LEISURE
TRAVEL VANS

Campaign Update CA#8641

Subject: 15 Amp Fuse instead of 30 Amp Fuse
Affects certain 2017 Unity models

QAAR 8641 400W Solar Panel Fuse replacement.

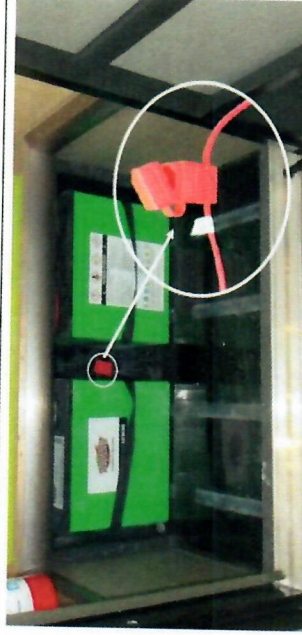
The red fuse mounted at the back of the compartment between the batteries must hold a 30 amp fuse for the 400W option.
Replace as needed and remove the 15amp sticker
